City of Franklin

Meeting Agenda

Historic Zoning Commission

Monday, October 13, 2025

425 BOYD MILL AVE

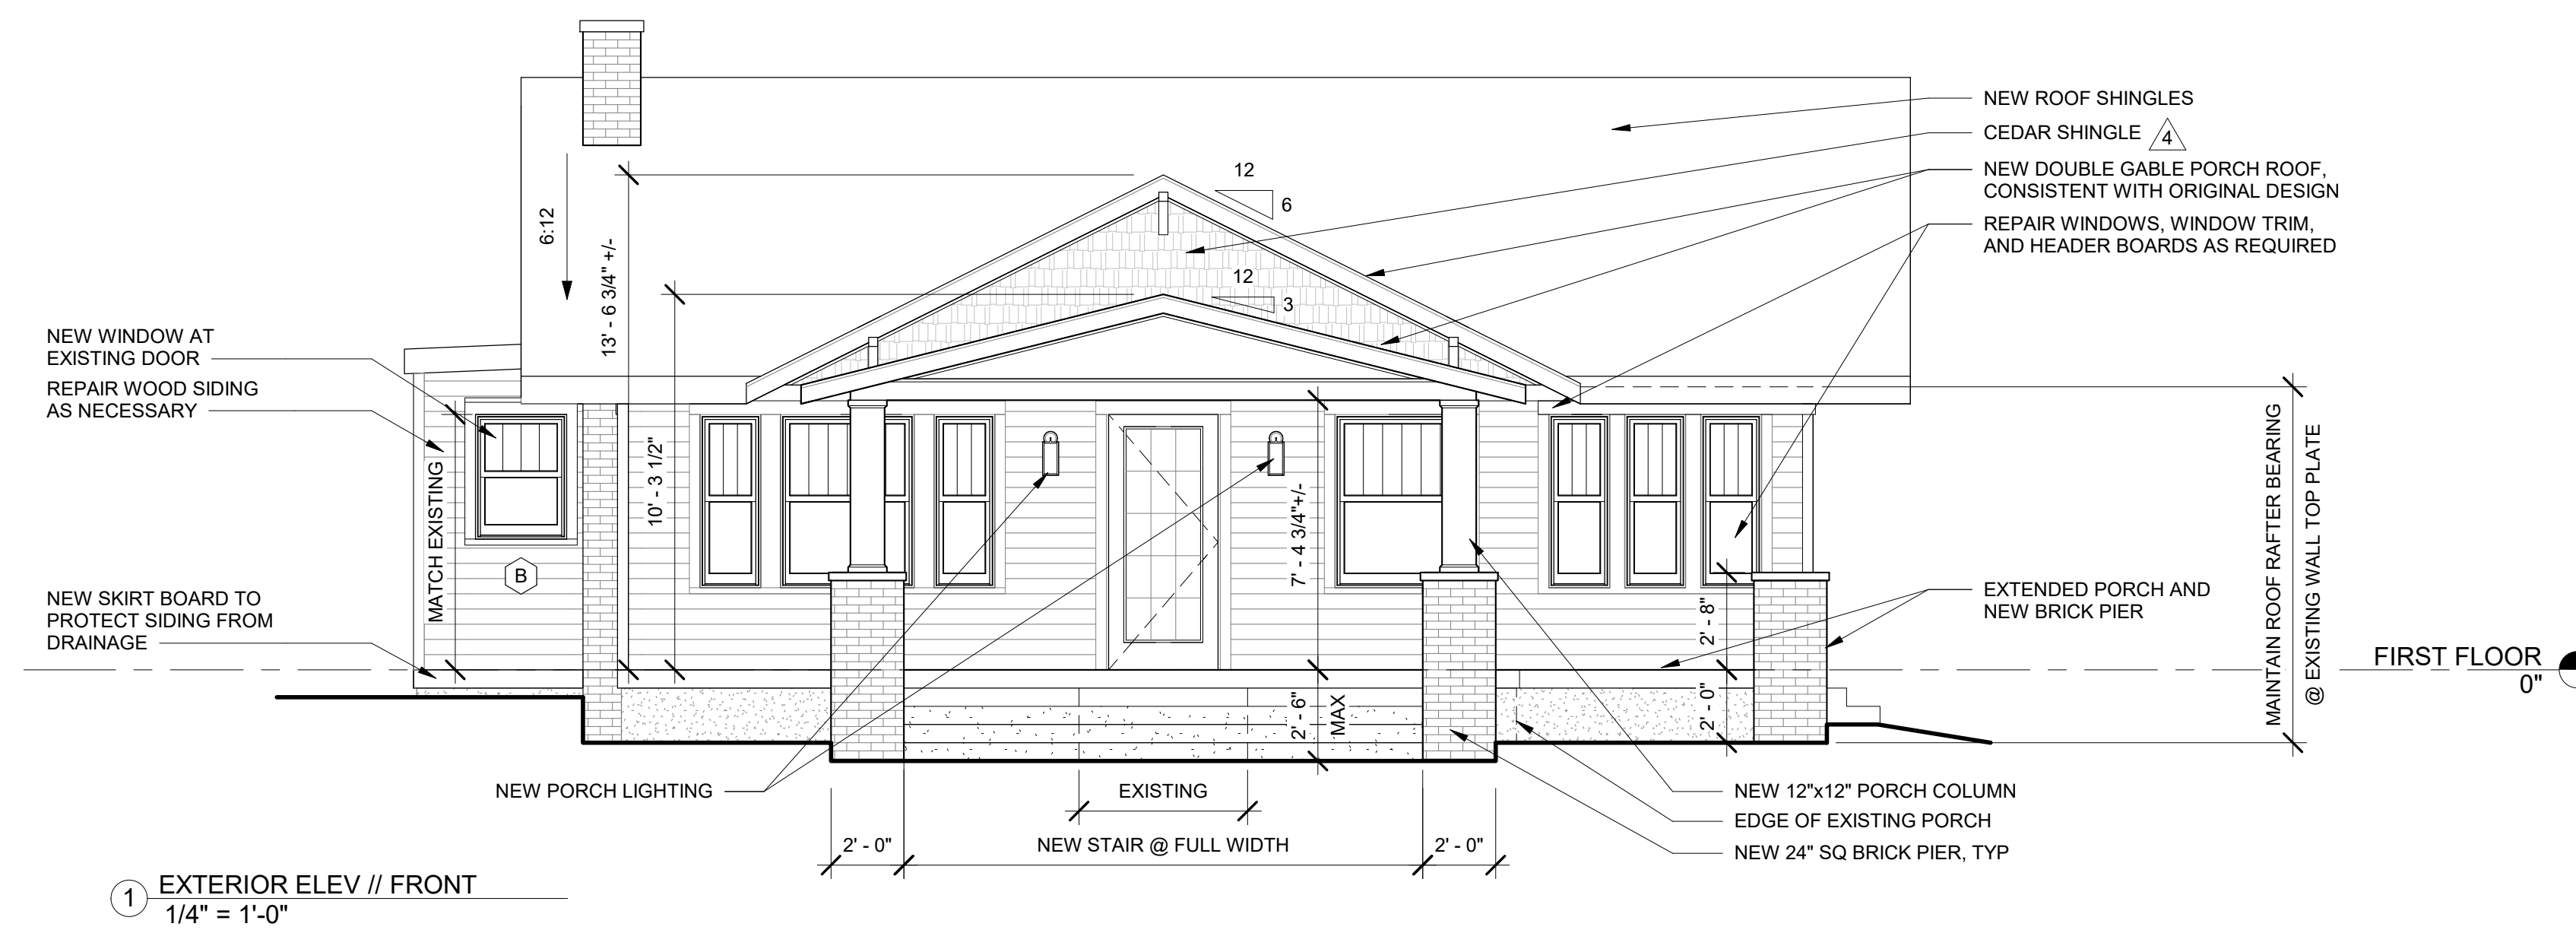
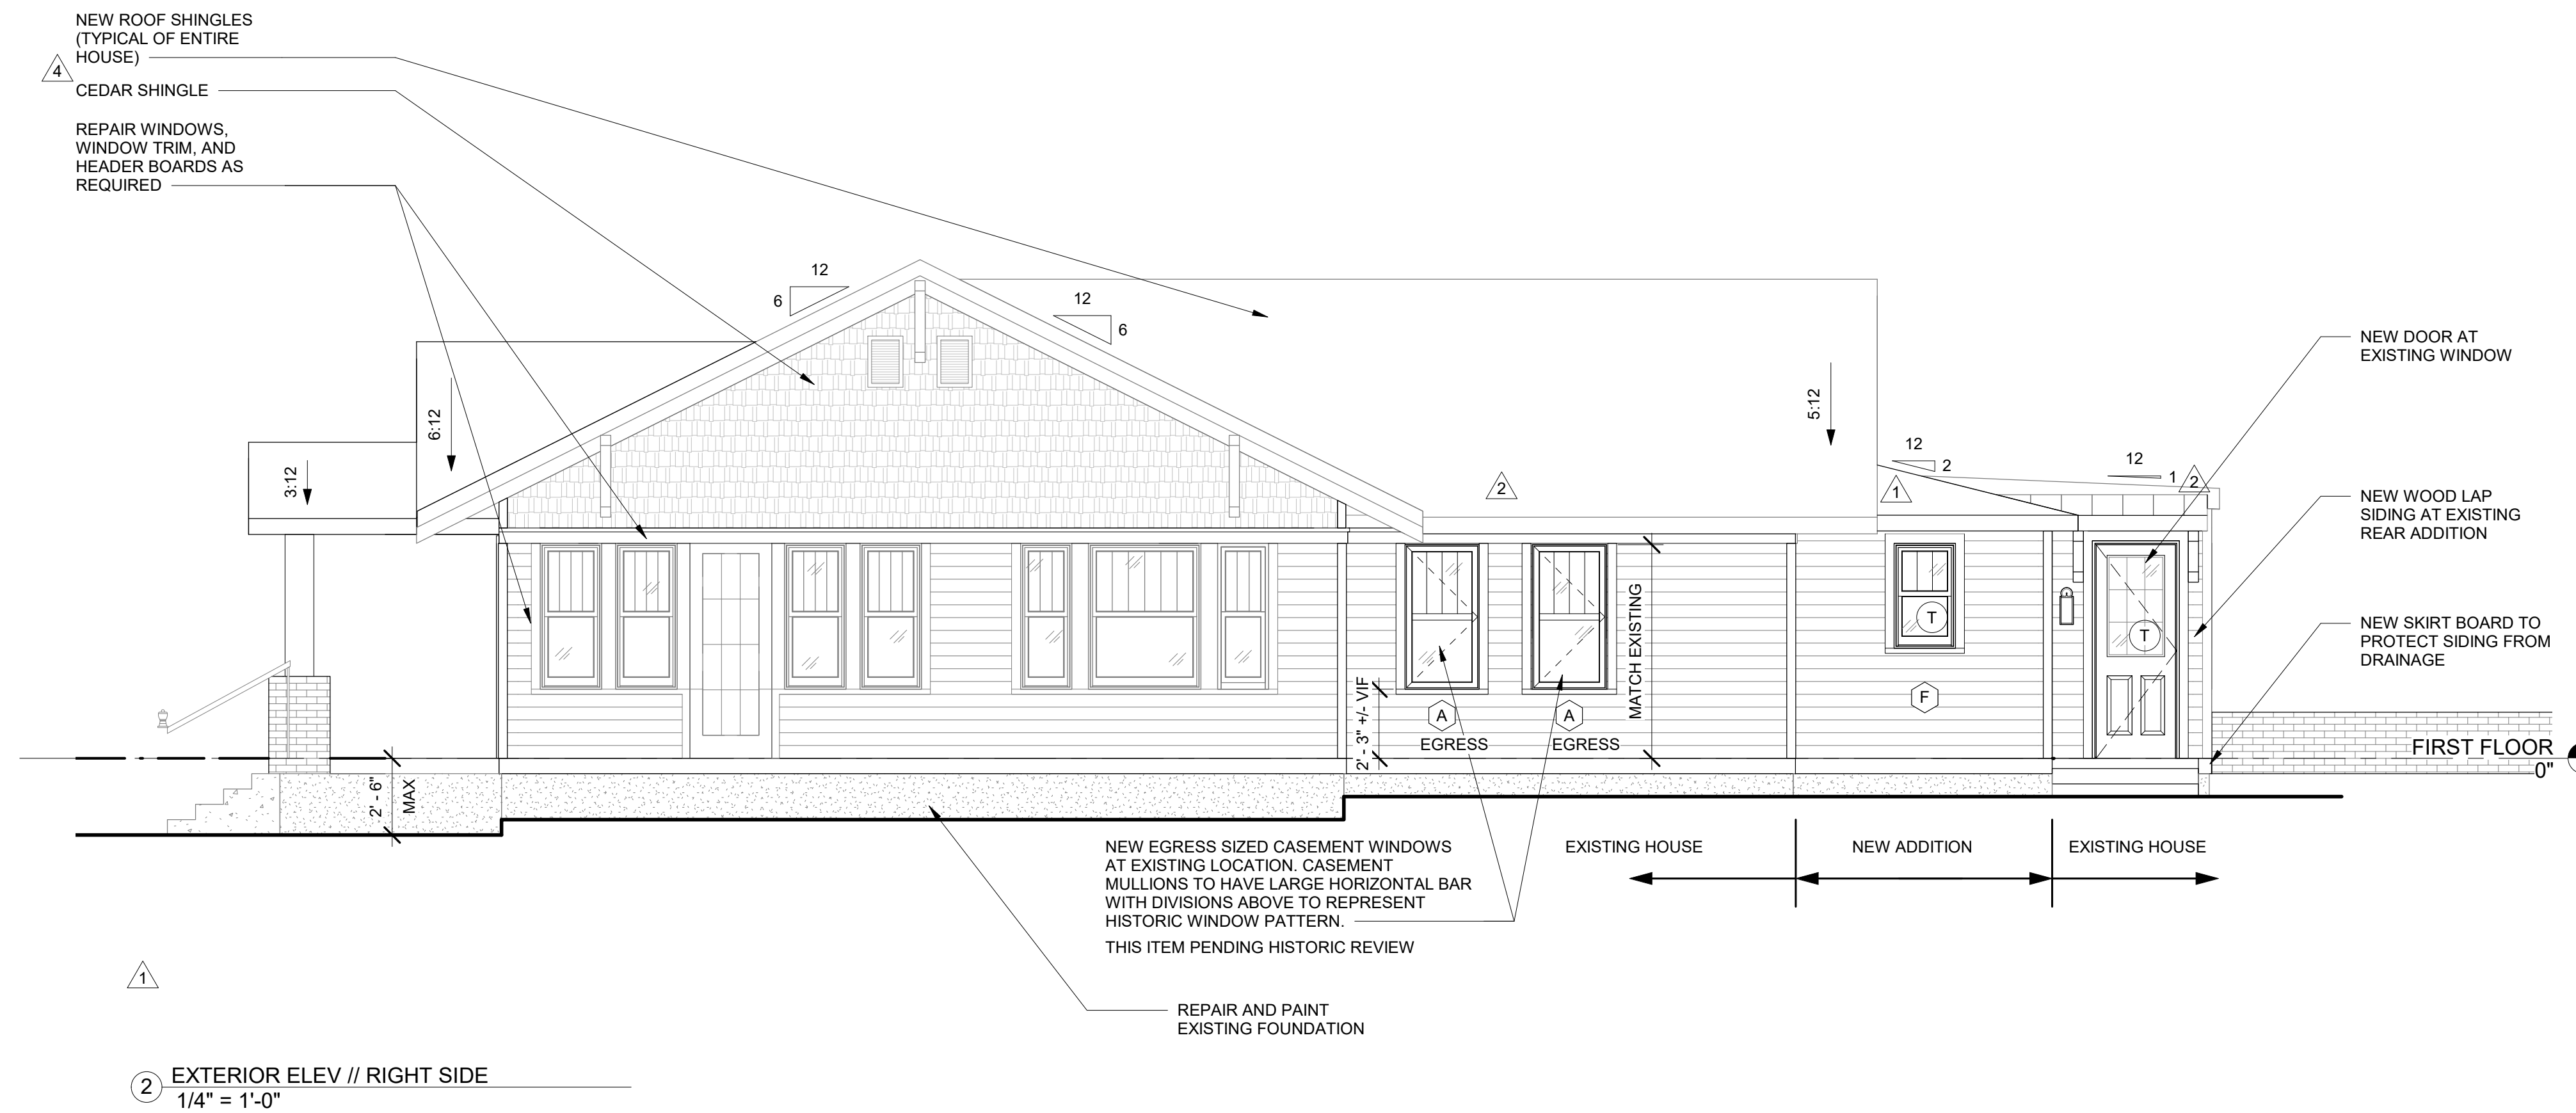
The proposal is to change the material of the reconstructed front porch gable from smooth paneling to cedar shake. The smooth panel material was approved in November 2023. At the time, the use of cedar shake in the gables was not proposed. The use of cedar shake as the material for the gables elsewhere on the building was approved in February 2025. It is difficult to discern the material of the front porch gable roof in the historic photo for which reconstruction was approved for the porch. The Guidelines recommend the following:

1. The application must meet all the requirements of the City of Franklin prior to issuance of a building permit.
2. Any additional changes to the approved plans must be returned to the Preservation Planner or the Historic Zoning Commission for review and approval.
